A BEAZLEY ARCHITECTURE LLC  
104 Dairy Lane  
Broussard, Louisiana 70518

RE: THE HARVEST CENTER CHURCH  
819 E SIMCOE ST.  
LAFAYETTE, LOUISIANA 70501  
PROJECT NO. 2025-006

Issued February 20, 2026

ADDENDUM NO. 2

1 Plumbing Floor Plan - Sanitary  
1/8" = 1'-0"

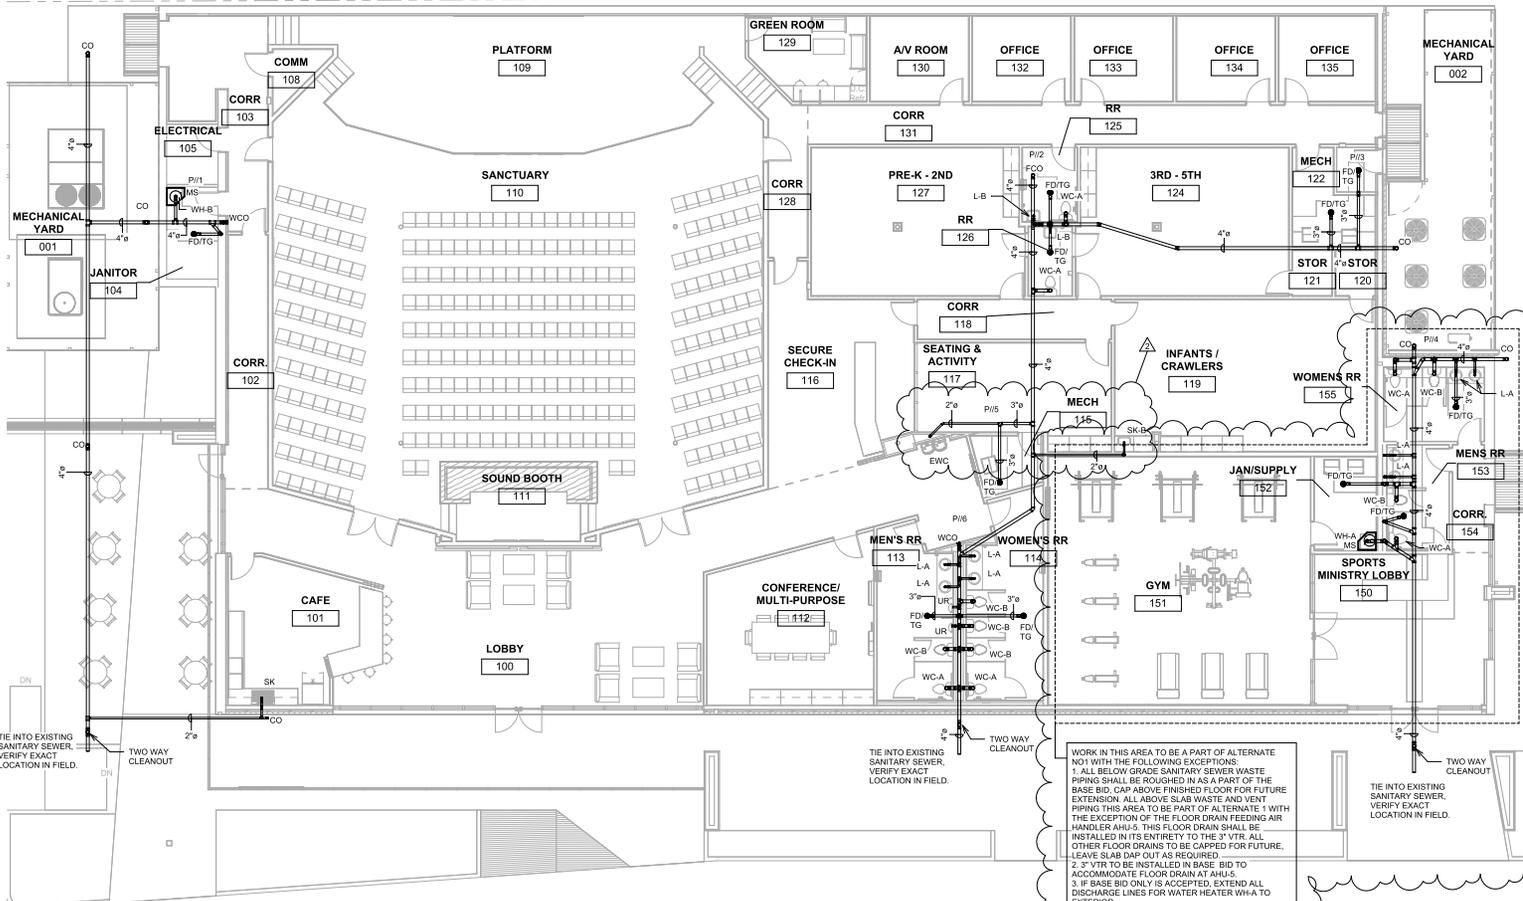
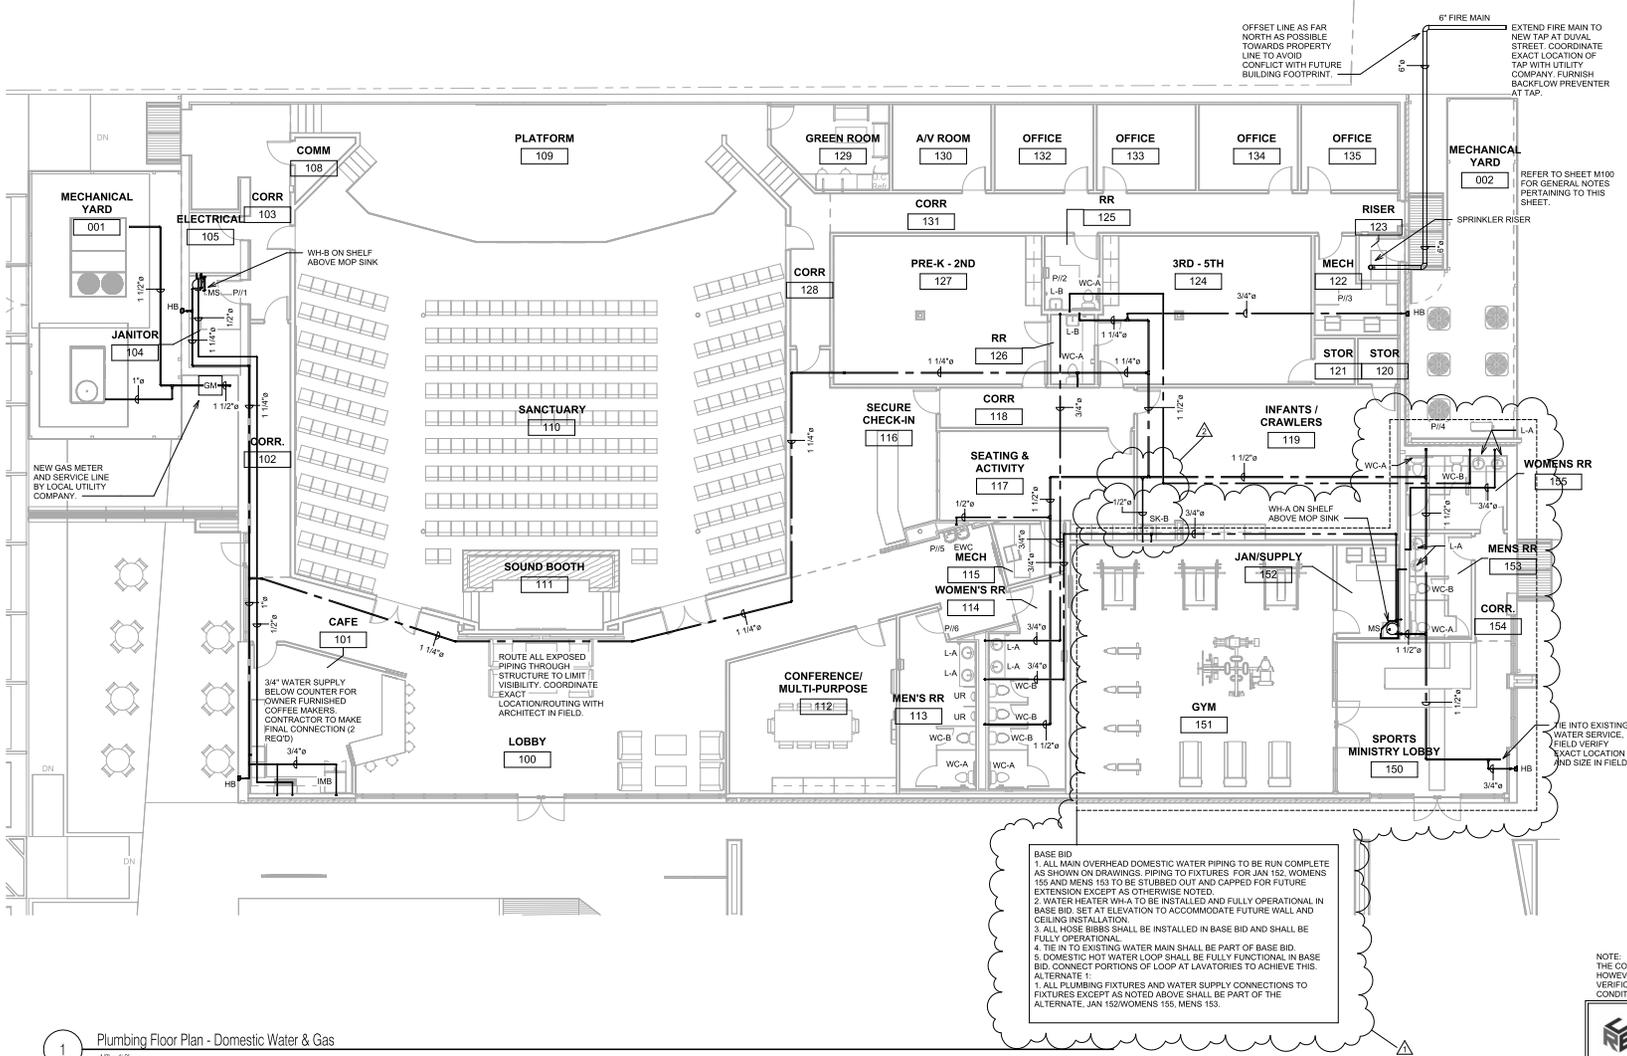
Replace with revision dated 2/20/26 showing revised plumbing information for the added sink in room 119.
